COUNCIL ASSESSMENT REPORT

Panel Reference	PPSSNH-662
DA Number	MOD2025/0062
LGA	City of Ryde
Proposed Development	Section 4.55(2) modification to LDA2023/0245 for the construction of two residential flat buildings, 18 multi dwelling housing units and adaptive re-use of the existing boat shed building to contain residential units and commercial/retail tenancies. This application proposes a number internal and external design modifications.
Street Address	20 Waterview Street, Putney (Lot 100 DP1313826)
Applicant Owner	Applicant: PMAP Putney P/L Owner: PMAP Putney P/L
Date of DA lodgement	11 July 2025
Total number of unique submissions	No submissions received to modification application
Recommendation	Approval
Regionally Significant Development (Schedule 6 of the SEPP (Planning Systems) 2021)	General development that has an estimated development cost of \$30 million. Section 4.55(2) application which results in a variation to a development standard of more than 10%.

Report prepared by	Shannon Butler – Senior Town Planner
Report date	24 September 2025

Figure 3 – Building height plane depicting elements of originally approved development encroaching above the maximum height limits

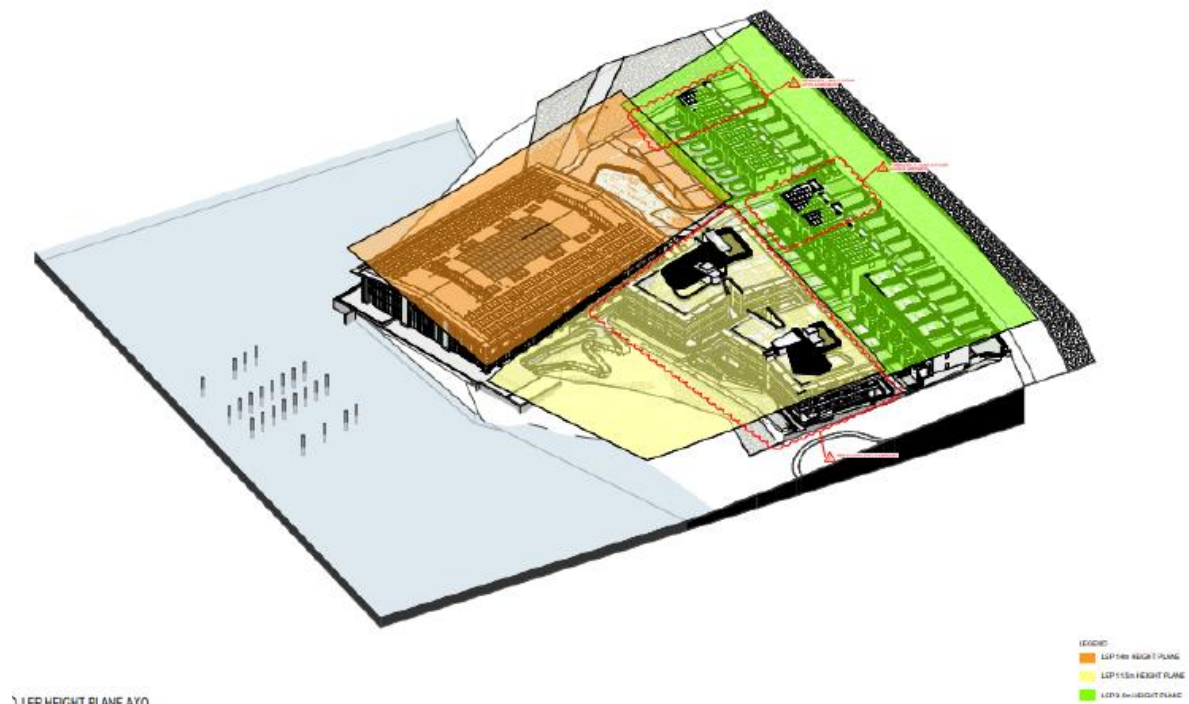
Figures 3 and 4 below depict the elements of the development originally approved encroaching over the maximum permitted building height and the elements now proposed to encroach:

The maximum minor height exceedance of the western townhouses - T.01, T.02 is 10m or a 5.3% variation above the 9.5m building height development standard. This is the result of the uneven topography of the site and increase in floor to floor heights to meet compliant standards. A very minor height exceedance between from 9.9-10m, is also proposed for the mid-townhouses - T.07, T.08 and T.09 resulting in a 4.2-5.3% variation to the 9.5m maximum building height standard in order to accommodate for the amended floor to floor heights, and resultant from the sloping nature of the site.

The height exceedance is predominantly limited to the relocation of the mechanical air handling units (AHU's) on the townhouses. Importantly, the surface area of these units is small in respect to the maximum building height that results from their relocation. Importantly, it should be noted that the proposed lifts in T7-T12, T14-T16 and T18 will not result in a lift overrun. As such, the height exceedances of the townhouses are a result of the rearrangement of the mechanical AHU's on the townhouse roofs.

The maximum height exceedance of the RFBs is 2.83m (26% variation) over the 11.5m building height development standard, resulting in a maximum building height of the RFBs of 14.33m. The proposed modifications to the height of the RFBs, will not result in any additional overshadowing or view impacts than originally approved.

It is considered that the applicant has adequately demonstrated that compliance with the development standard is unnecessary or unreasonable. The elements encroaching above the height limit are not of a bulk and scale which will result in

impacts and are limited to lift overruns, rooftop stair access and pergola structures. For the townhouses, the building height departures arise largely as a result of the topography and result in minimal impact.

It is considered that the applicant has adequately demonstrated that there are sufficient environmental planning grounds to justify contravening the development standard. The building height variations occur partially due to the topography of the site which falls from Waterview Street to the waterfront and there is an additional crossfall from east to west. The elements of the buildings encroaching above the height limit do not add to the bulk and scale of the development and are generally lightweight, ancillary elements. Any overshadowing generated by the encroaching elements falls within the subject site.
